Summary of Items Discussed in 4/2014 APSEC Discussion Forum on 8 August 2014

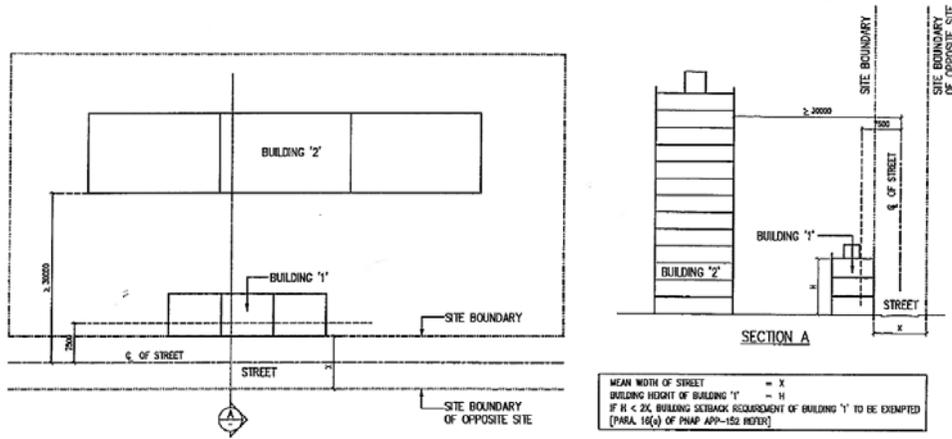
architectural projection in GFA and obtain exemption for the rest.	
3.	<p><u>SBD Guidelines - Interpretation of Set Back requirements</u></p> <p>Para 16(a) of PNAP APP-152 states that the building set back requirements may be exempted if the height of the ‘building’ is less than 2 times the mean width of the street. In the case of a site with more than one buildings in a site, it is our understanding that the height of the ‘building’ is taken to be the height of that particular building which is abutting or close to the public street concerned, but not the height of the highest building within the same site if such other building(s) are not less than 30m away from the centre line of the public street concerned and are by themselves satisfying the Building Set Back requirement.</p> <p>As exemplified by the sketch plan, the low block building ‘1’ should be exempted from the building set back requirement as its height is < 2 times the mean width of the abutting street and the higher building ‘2’ is not less than 30m from centre line of the street. Please confirm our understanding is correct.</p>	<p>The BD advised that the building set back requirements for separate buildings in the same site should be considered separately, each according to its own circumstances.</p>

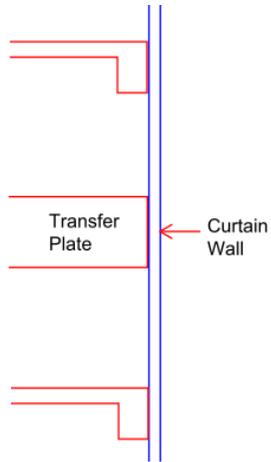
along column is accepted as long as the column was a genuine column.

- (i) By the same token, would like to confirm curtain wall at external face of transfer plate shall be accepted as the transfer plate shall be a genuine structural element and no additional building bulk is created.

- (i) The BD confirmed that the transfer plate would be treated in a similar manner as columns in a typical floor. As such, the curtain wall outside the transfer plate would be ignored in the GFA calculation.

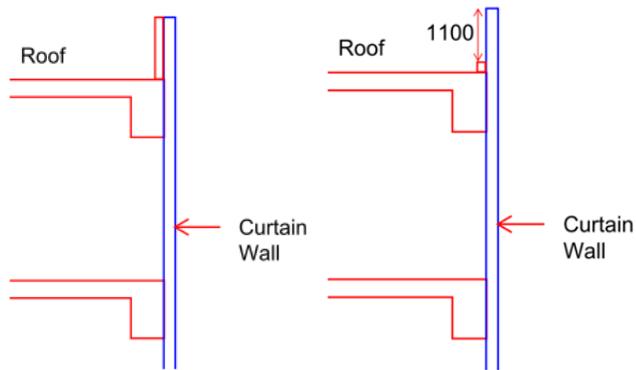
- (ii) Also, would like to confirm curtain wall at external face of roof RC parapet wall shall be accepted as roof area to be non-GFA accountable and no additional building bulk is created, the curtain wall along the roof RC parapet wall shall be accepted and to be non-accountable for GFA and SC.

Should RC parapet wall was replaced by 150mmH RC curb with curtain wall as protective barrier, the curtain wall at roof periphery shall be accepted and non-accountable for GFA and SC.

- (ii) Diagram on the Left – the BD confirmed that the curtain wall thickness should be ignored in considering PR / SC. Diagram on the Right – the BD confirmed the same but raised concerns for the lateral load for barrier to be supported by the curtain wall rendering the proposed curtain wall not meeting the acceptance criteria under PNAP APP-2.

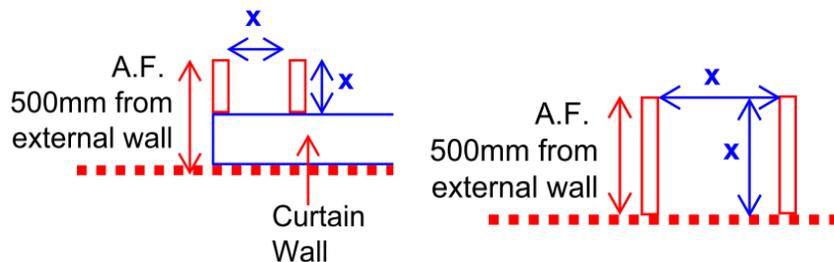
(b) Item 15 in Discussion Forum 5/2012 held on 26 Oct 2012: Architectural features not exceeding 500mm from external walls of a building are accepted to be incorporated in a curtain wall design and to be non-accountable for GFA and SC

There has been requirement to maintain certain separation between the 500mm architectural features but there are no standards for AP to follow. Please advise the acceptable separation distance between these features.

(b) The BD noted and advised that it would review and consider.
